Access Compliance Report

Public Rights-of-Way (Curb Ramps)

Intersection ID: 9814	Main Street: CLIFTON_ST	Cross Street: PATTON_AV	Location: SE
ADA ID: D28B30328609	Ramp Type: Directional1	Initial Pass/Fail: Fail	Overall Compliance: No
		Severity Score: 12.5

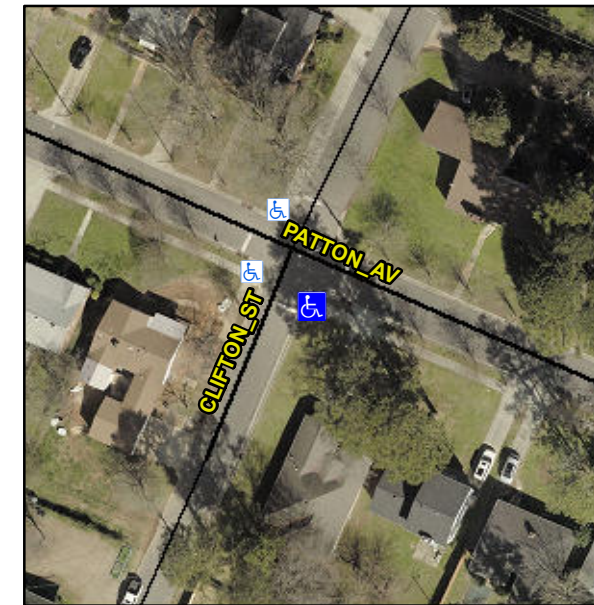
R304.2.2

Compliance	Description	Data	Compliance	Description	Data
N/A	Ramp Length (in)	129.5	N/A	Grade Break?	N/A
Yes	Ramp Width (in)	59.0	N/A	Grade Break Slope (%)	0.0
No	Ramp Slope (%)	8.6	N/A	Grade Break XSlope (%)	0.0
Yes	Ramp XSlope (%)	1.2			
N/A	Flare Type LT	N/A	N/A	Flare Type RT	N/A
N/A	Flare Slope LT (%)	N/A	N/A	Flare Slope RT (%)	0.0
N/A	Flare Traversable LT?	N/A	N/A	Flare Traversable RT?	N/A
N/A	Landing Length (in)	0.0	N/A	DWS Provided?	N/A
N/A	Landing Width (in)	0.0	N/A	DWS Contrast?	N/A
N/A	Landing Slope (%)	0.0	N/A	DWS Length (in)	N/A
N/A	Landing X Slope (%)	0.0	N/A	DWS Full Width?	N/A
N/A	Landing Curb? (Y/N)	N/A	N/A	DWS Offset LT (in)	N/A
N/A	Shared Landing?	N/A	N/A	DWS Offset RT (in)	N/A
N/A	Gutter Ponding?	0.0	N/A	Gutter Slope (%)	N/A
N/A	Gutter Lip Ht (in)	0.0	N/A	Gutter X Slope (%)	N/A
N/A	Painted X Walk1?	No		Road Slope (%)	1.2
	X Walk 1 Direction	To NW		Road X Slope (%)	2.9
	X Walk 1 Width (in)	N/A		Clear Space?	N/A

Remove & Replace Entire Ramp.
